PARKS AND RECREATION COMMISSION QUESTIONS
November 9, 2022 MEETING

5.1. Evelyn Park Conceptual Review and Recommendation, Project 21-60

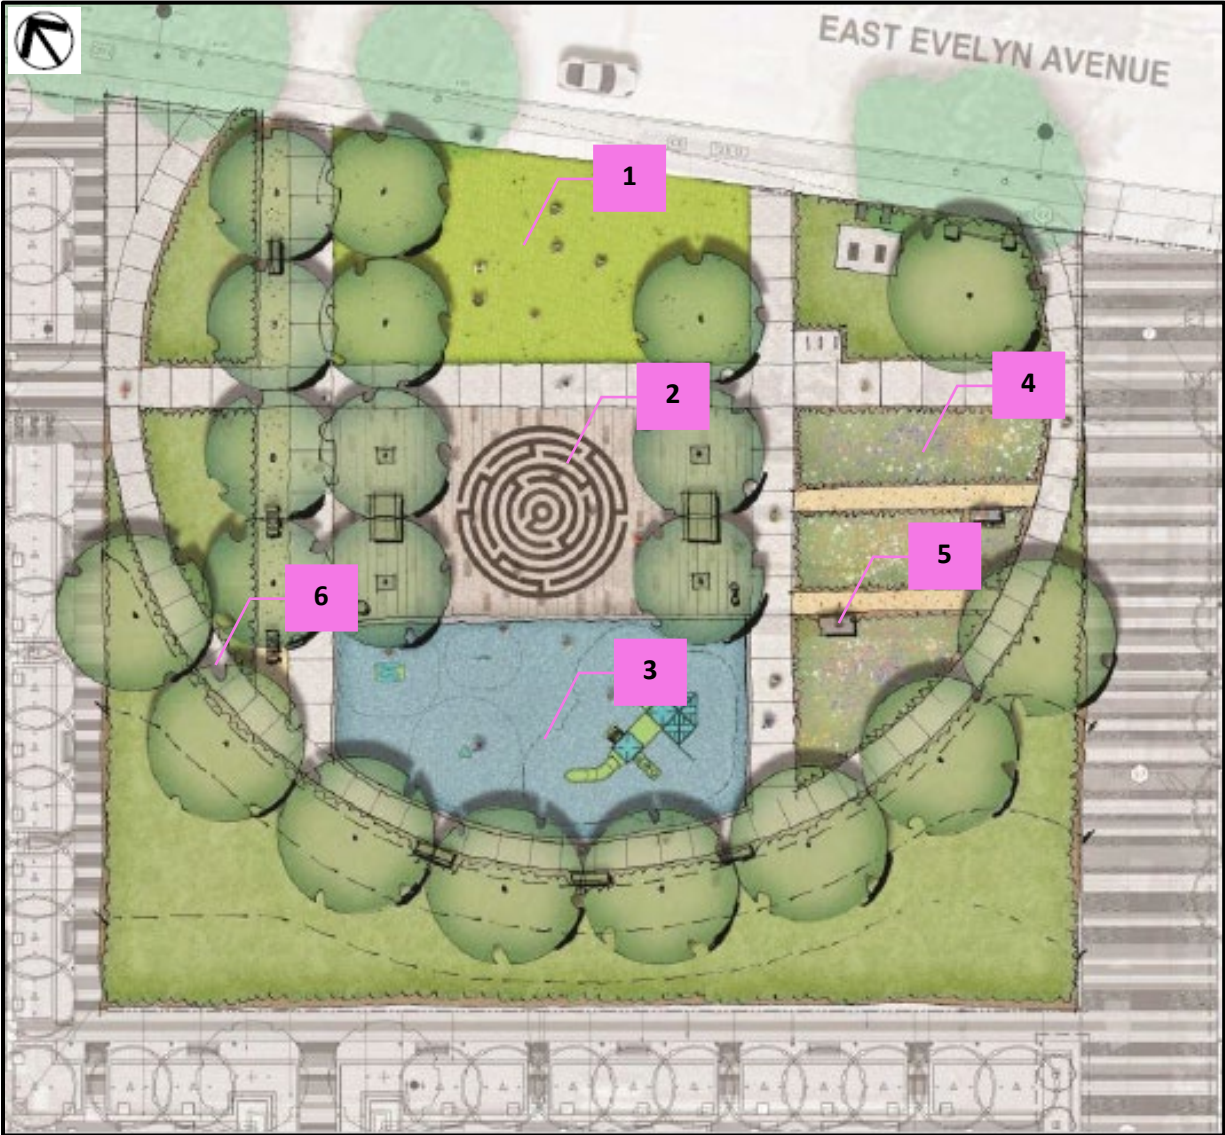
5. Could staff add a visual to the presentation to put the park in context? In other words, could we have a photo/planning visual to show what the building frontage looks like?

Yes, staff will include a visual in the presentation that adds this context.

Concept C

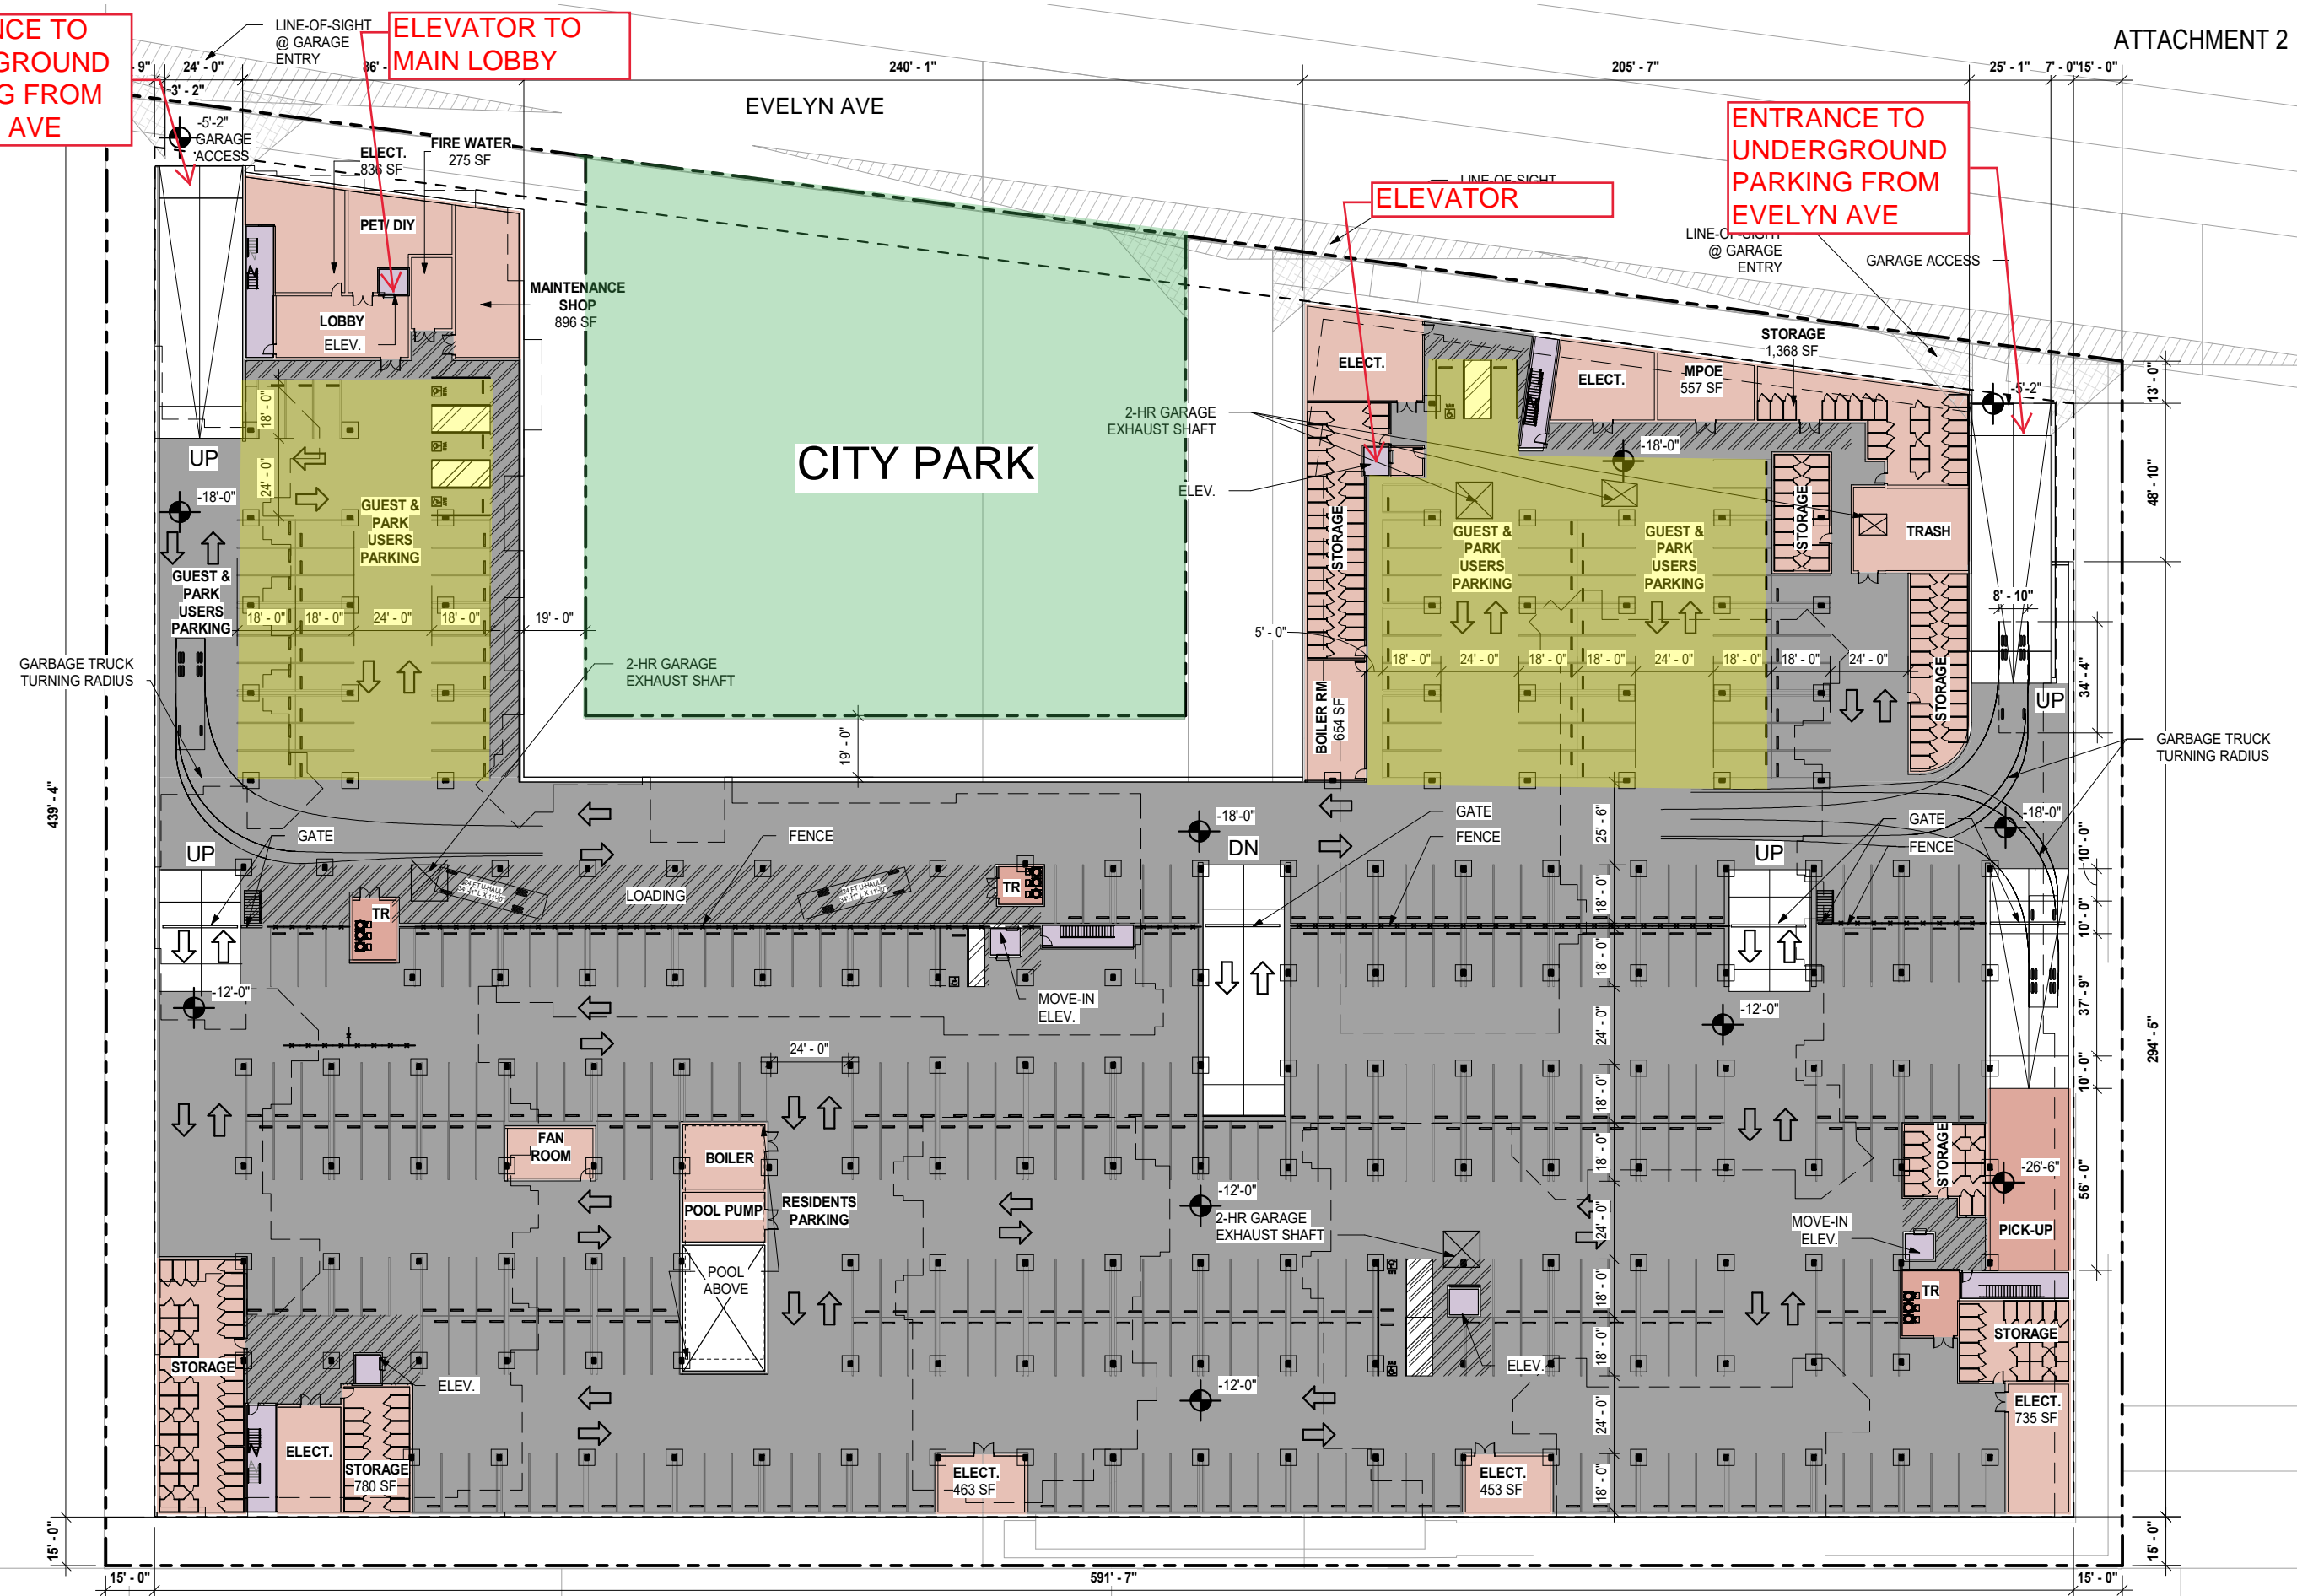
3. Since only three people attended the second community meeting, can you share the other two conceptual plans that were presented at that meeting (as well as highlight a few of their differing characteristics).

Attachments 1 and 2 illustrate the other two conceptual plans (Concepts B and C) that were presented at the second community meeting.
